Access Compliance Report

Public Rights-of-Way

| Intersection ID: 24261 | Main Street: REA_RD | Cross Street: CHADWYCK_FARMS_DR | Location: E |
| ADA ID: 71AF3CE595E2 | Ramp Type: PerpDiag | Initial Pass/Fail: Fail | Overall Compliance: No |

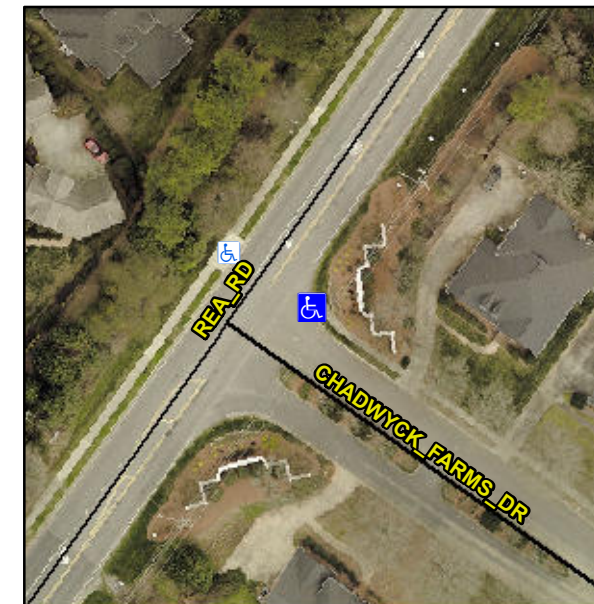
R304.2.2, R304.5.3

| Compliance | Description | Data | Compliance | Description | Data |
|------------|-----------------------|-------|------------|-----------------------------|-------|
| N/A | Ramp Length (in) | 48.0 | No | Ramp Slope (%) | 11.4 |
| Yes | Ramp Width (in) | 48.0 | No | Ramp XSlope (%) | 7.0 |

Remove & Replace Curb Ramp With Two New Directional Ramps or Equivalent.
